Security and CPTED Report

Project Address: 216-238 Keira St, 221-291 Crown Street and
86-90 Burelli Street, Wollongong, NSW
2500

Report Ref: 390844-Wollongong Developments No.8-
CPTED-Report-RevH

10.0 Annex A – CPTED Mark-up of Architectural Plans

DEVELOPMENT APPLICATION	
Drawing Name	Level 26 - 29 Plan
Drawing No.	DA2021
Revision	A
Scale	1:250 @ A1

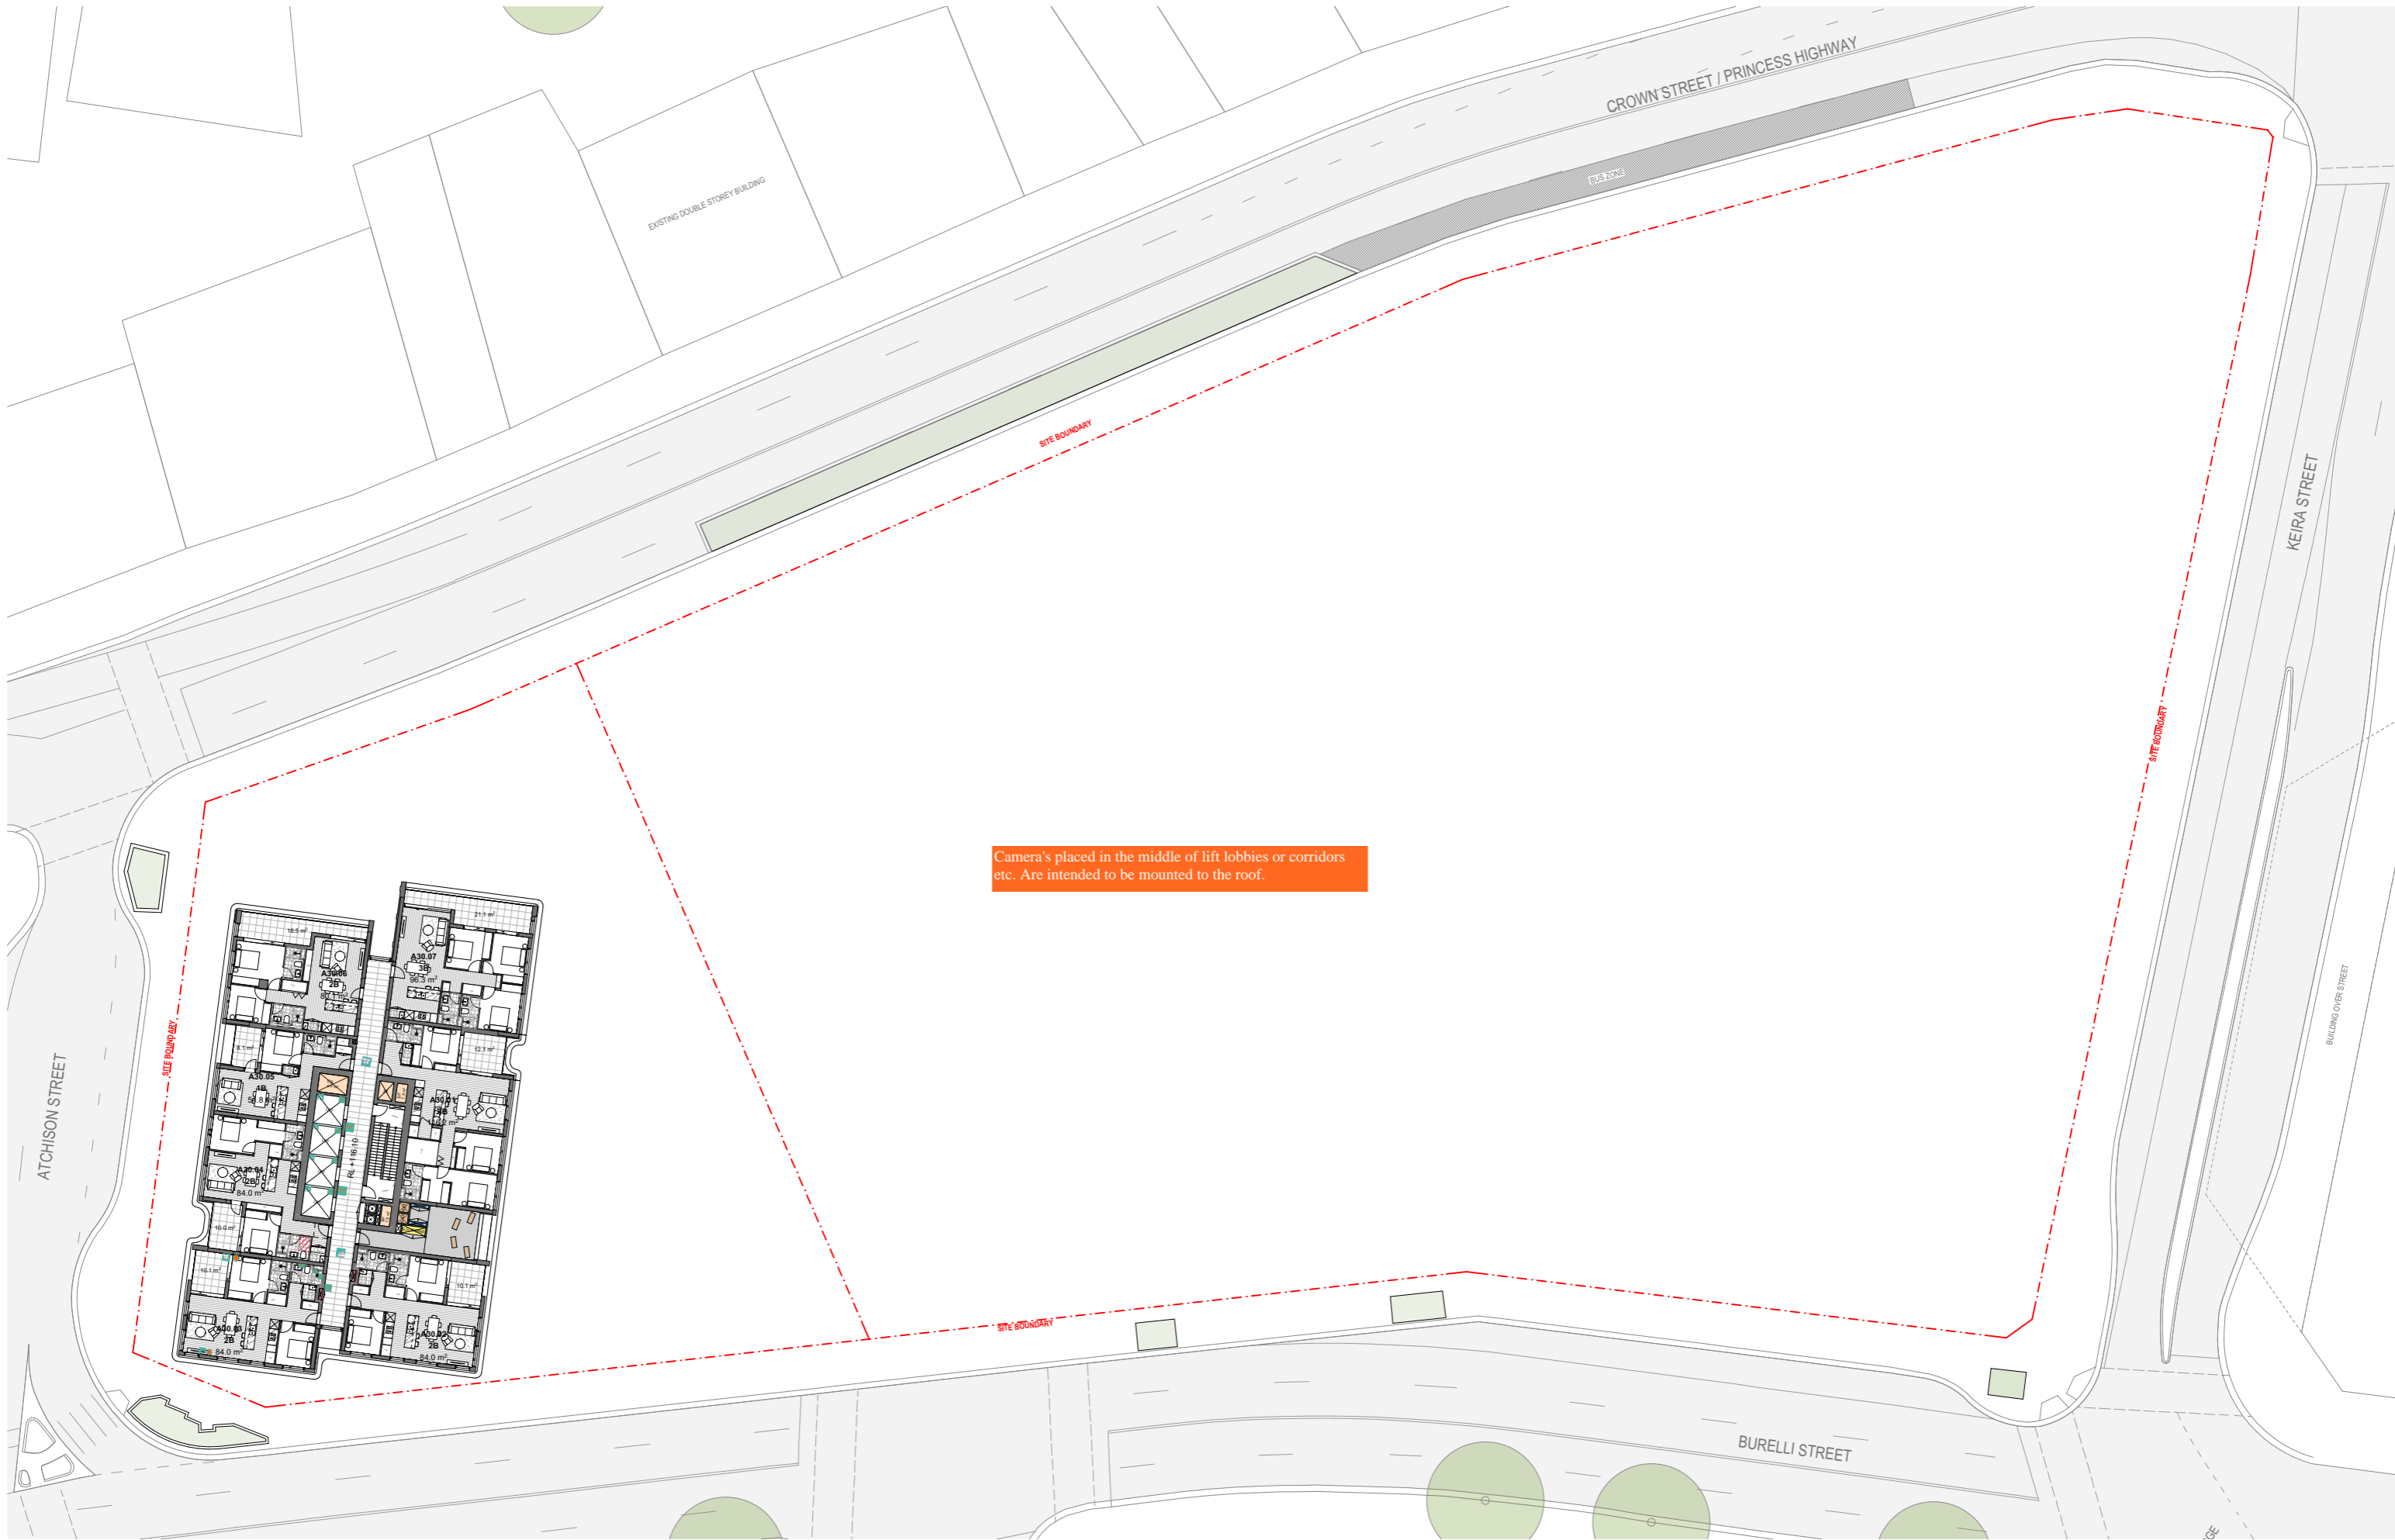
Camera's placed in the middle of lift lobbies or corridors etc. Are intended to be mounted to the roof.
